Revisions:	Date:
ADDENDUM 1	08-09-24
ADDENDUM 2 (NO STRUCTURAL CHANGES)	XX-XX-XX
ADDENDUM 3	01-17-25
ADDENDUM 4	02-04-25

Drawing Title: **FOUNDATION AND SLAB PLANS**

Location: **SIoux FALLS VAMC**
 SIoux FALLS, SD 57005

Project Title: **DESIGN REPLACE BOILER PLANT**

F1 GROUND FLOOR FOUNDATION PLAN
1/8" = 1'-0"

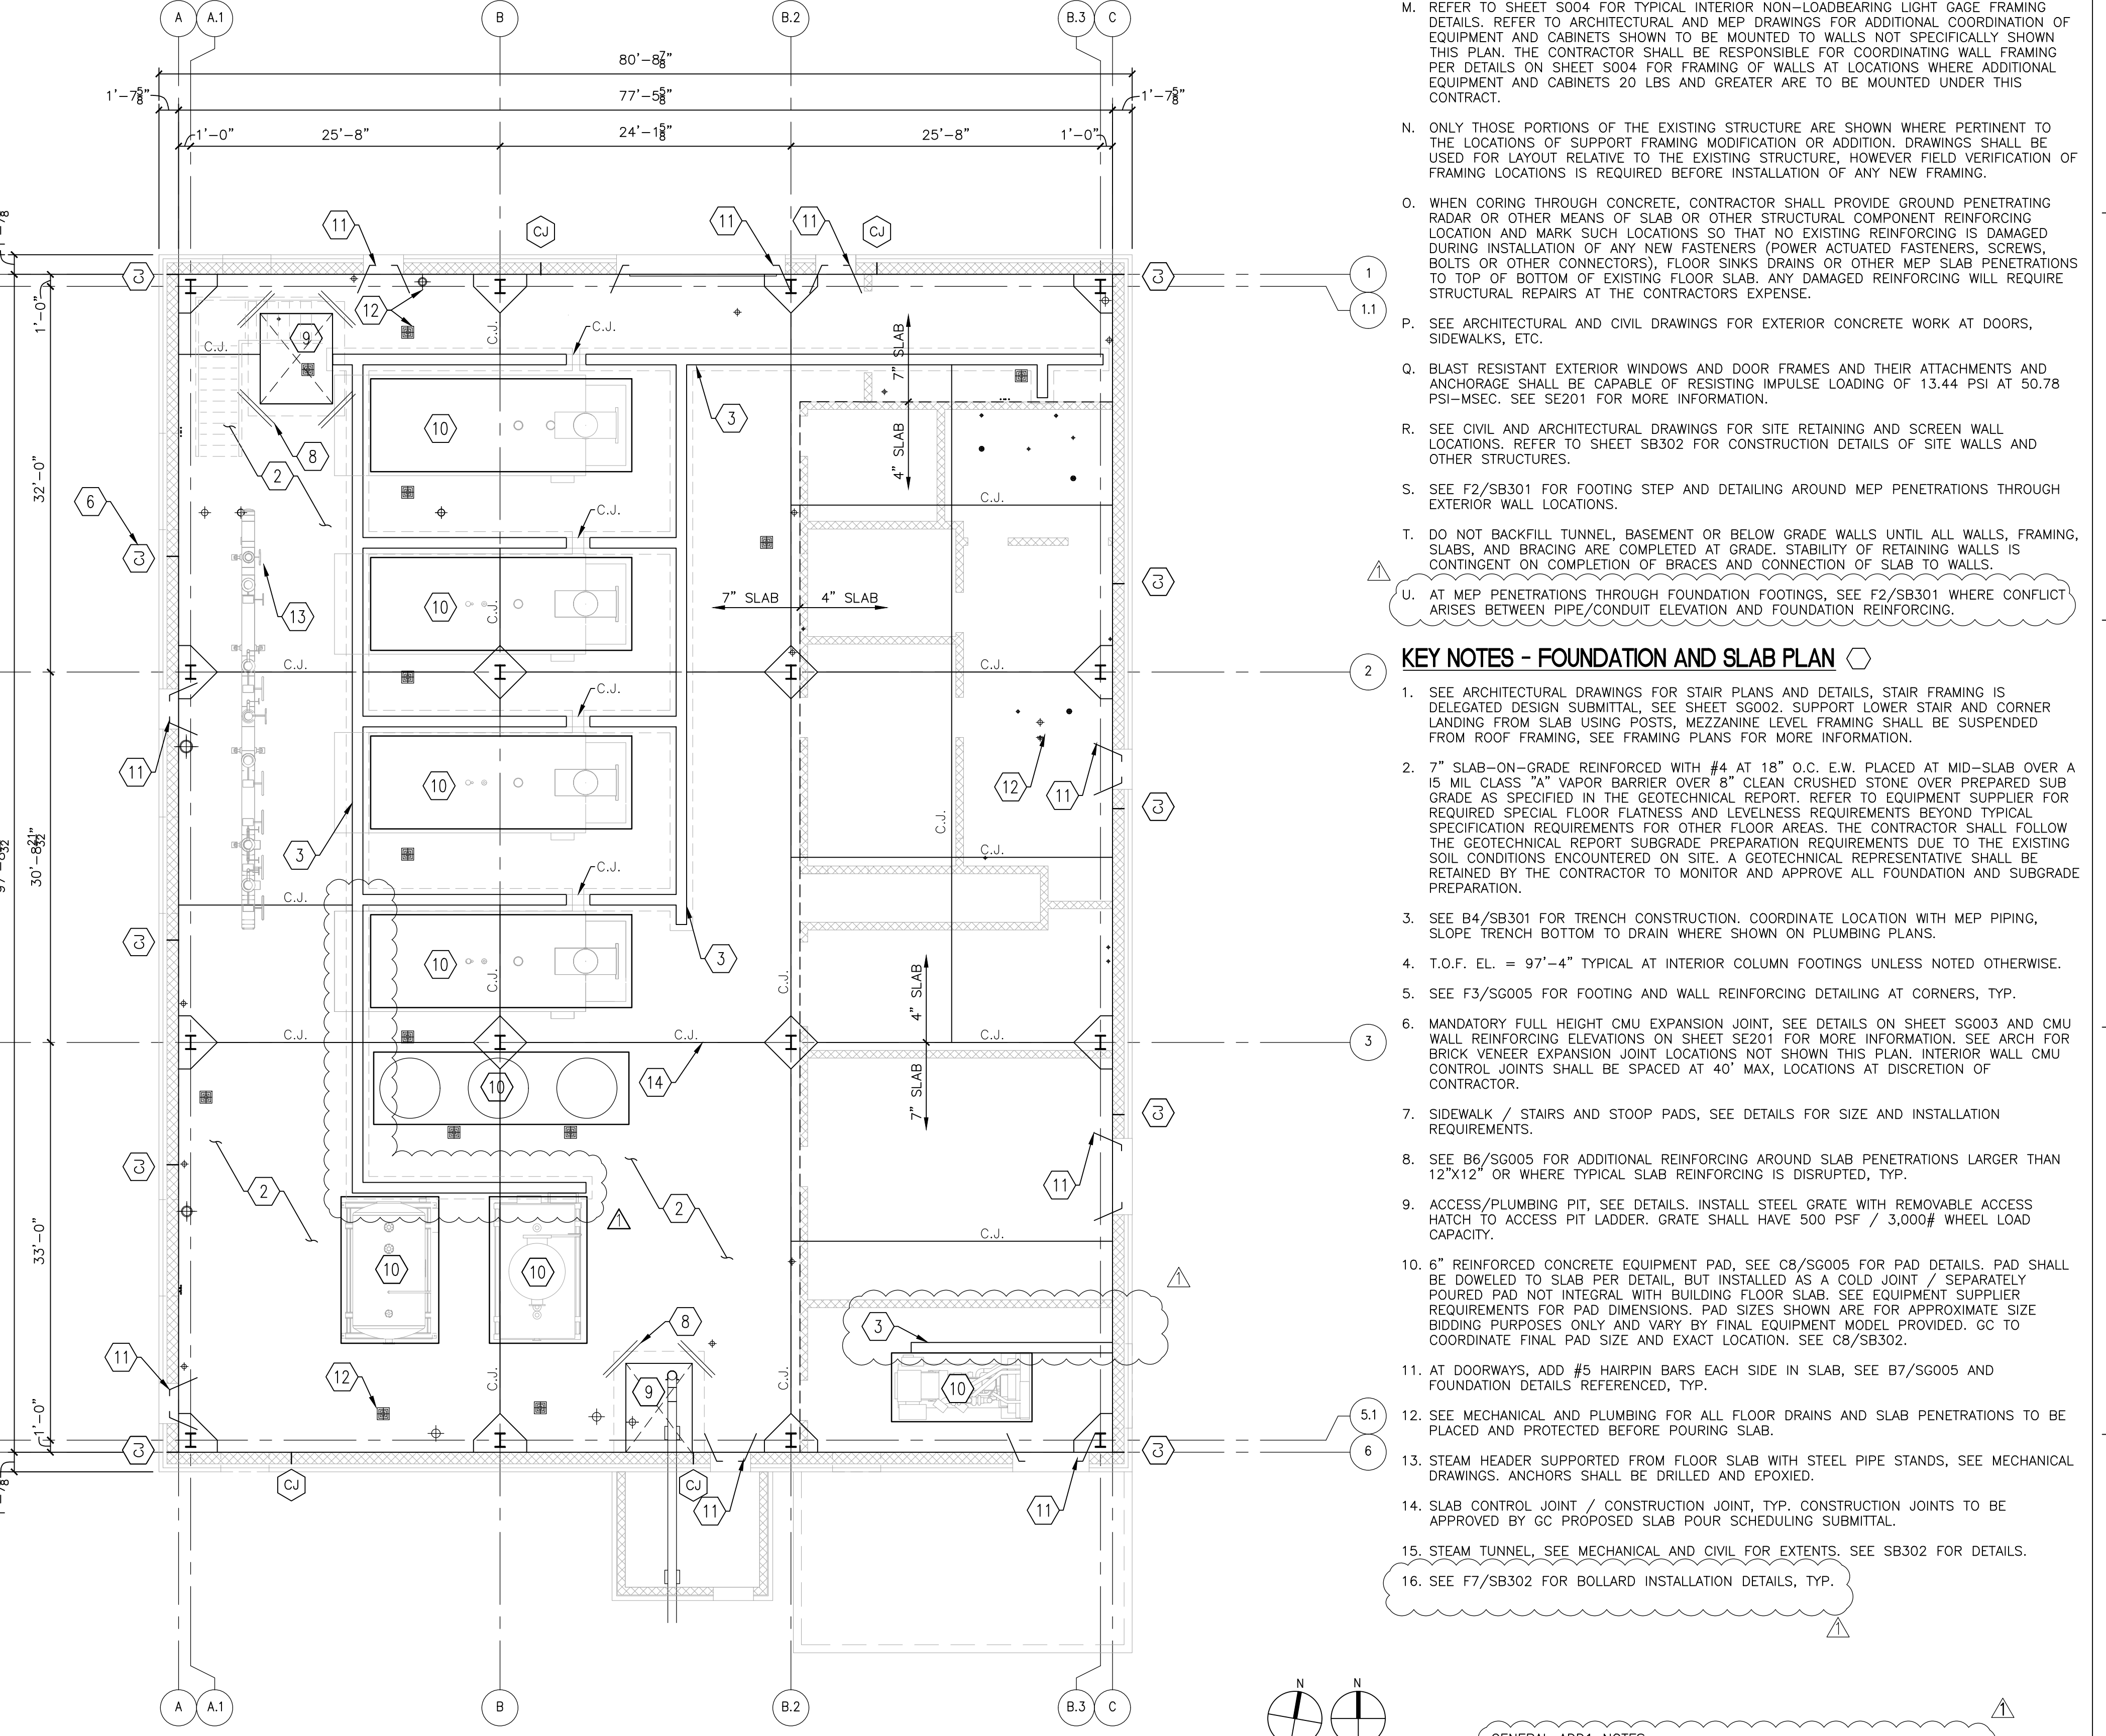
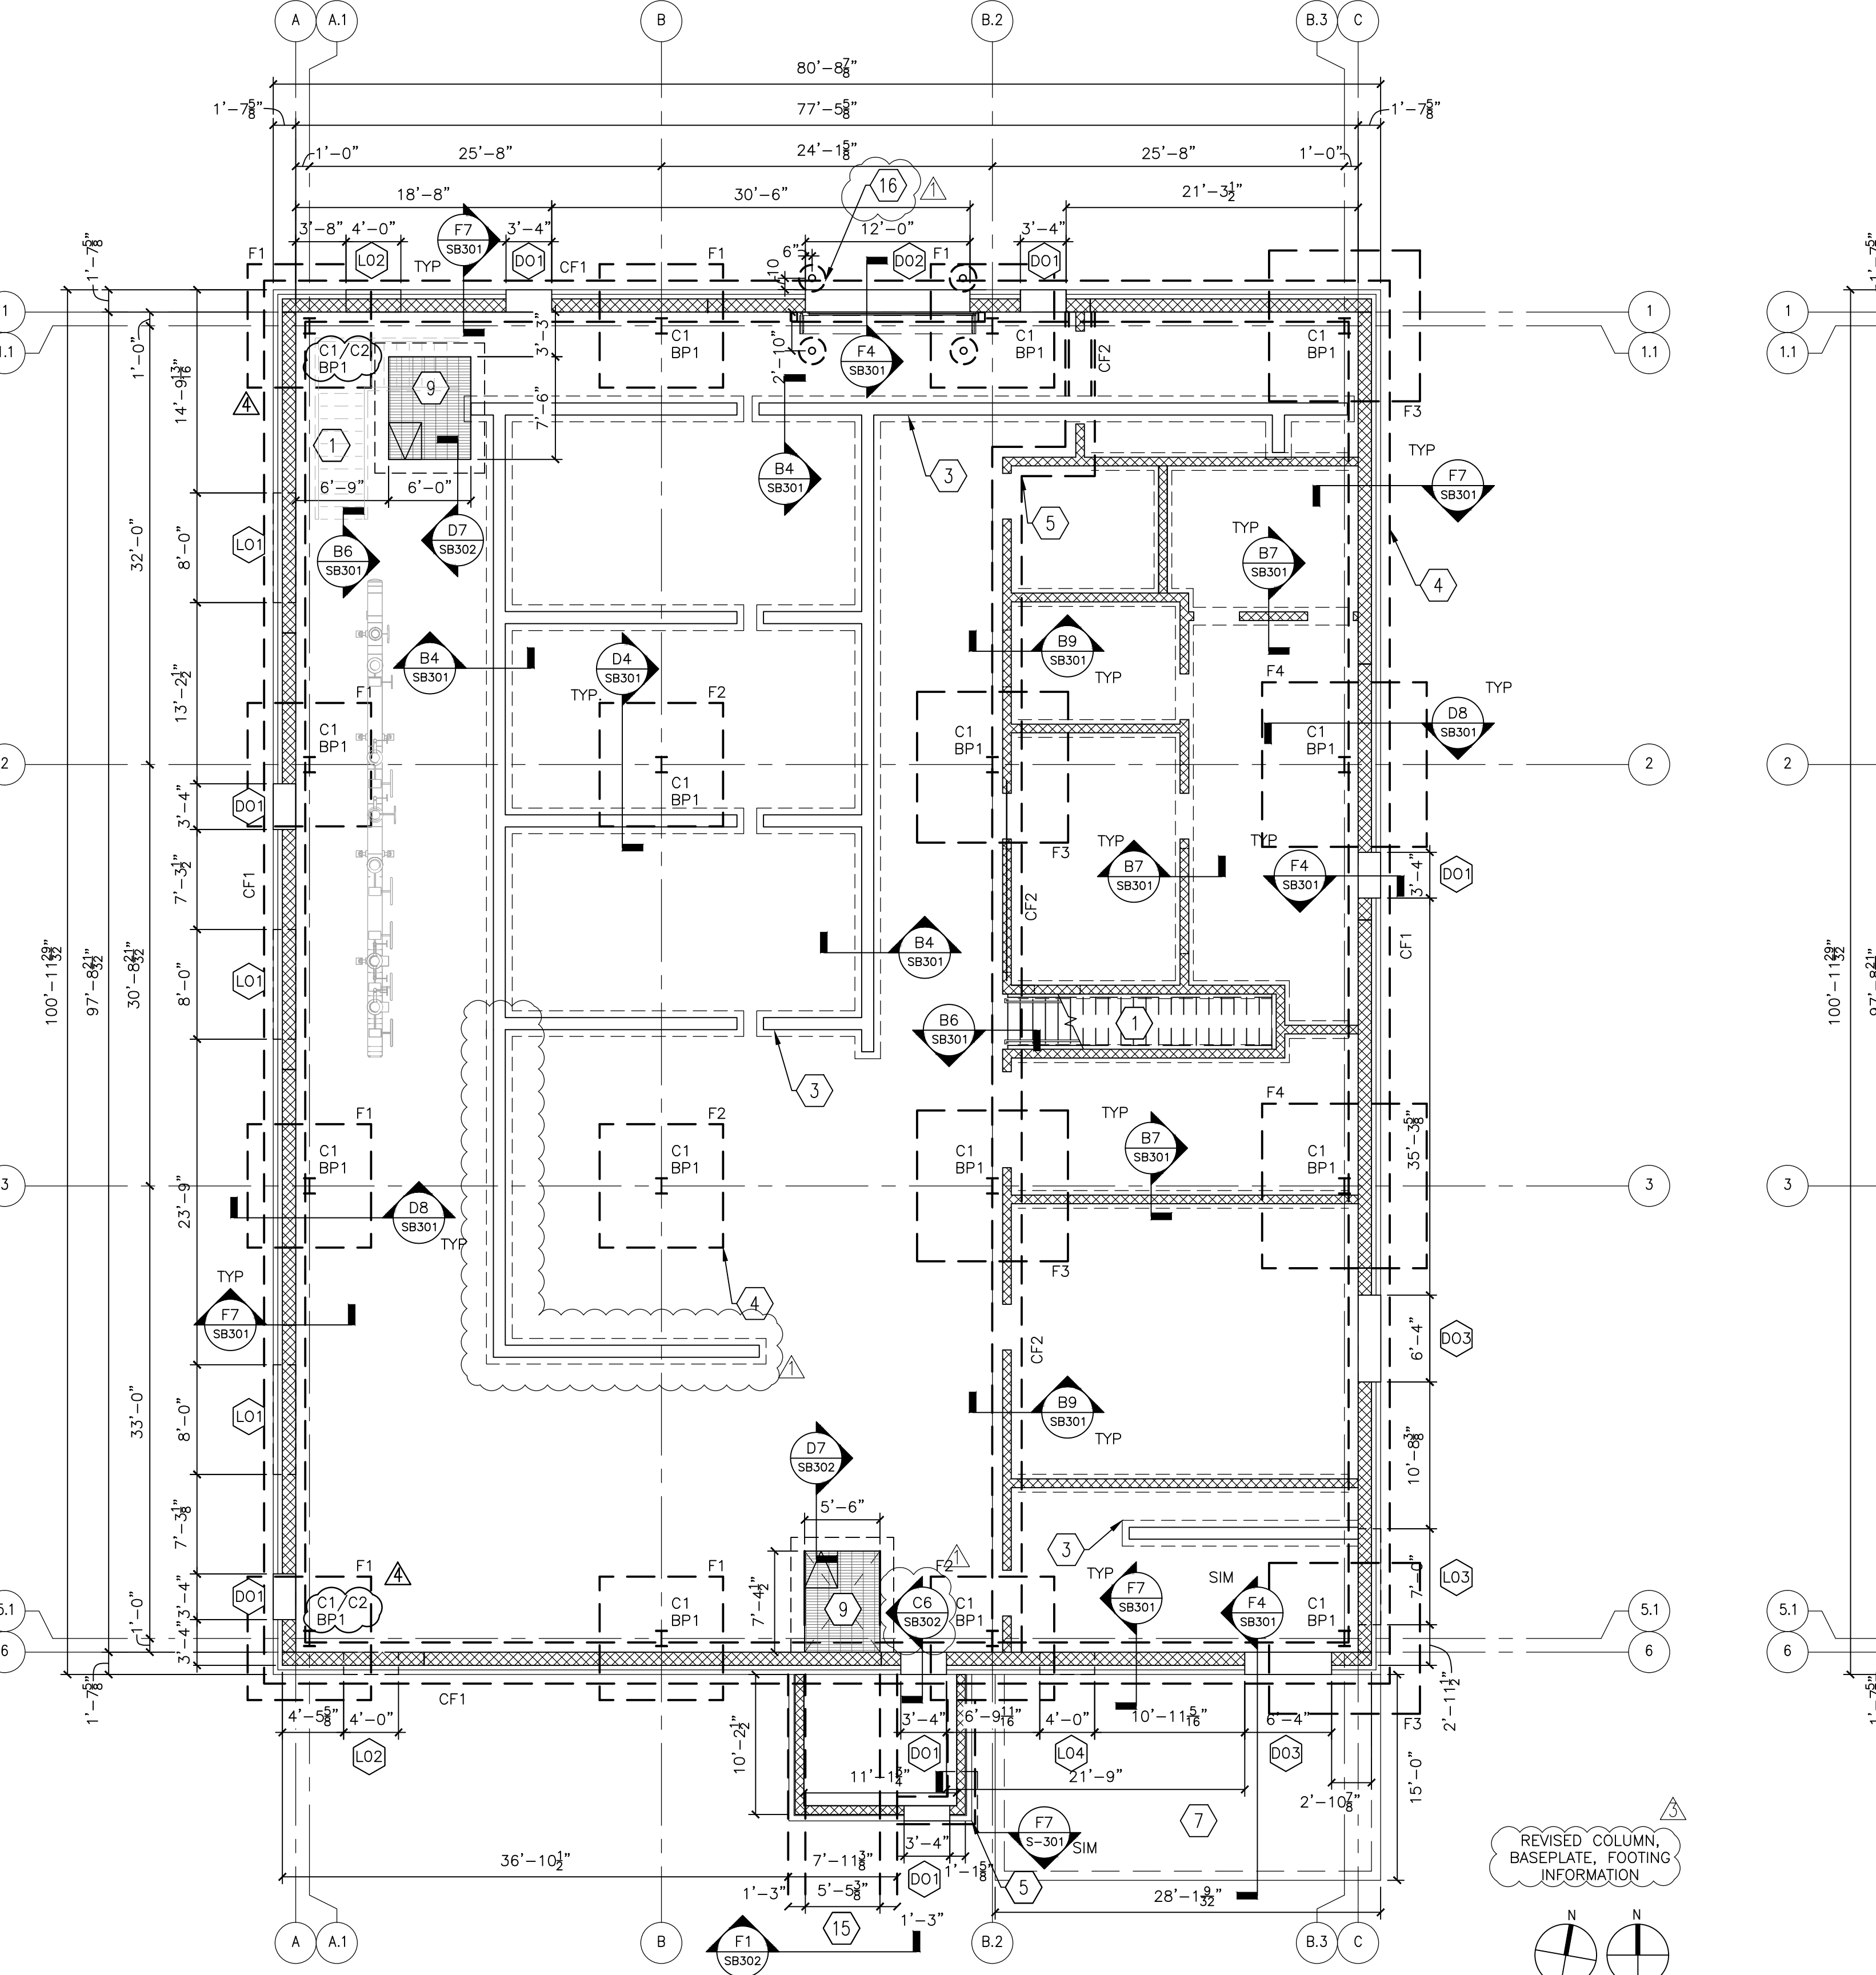
GENERAL ADD1 NOTES:
 ADDED TYP WHERE APPLICABLE TO NOTES AND DETAIL FOR CLARITY.
 ADDED KEYNOTE CALL-OUTS TO TYP. ITEMS FOR CLARITY
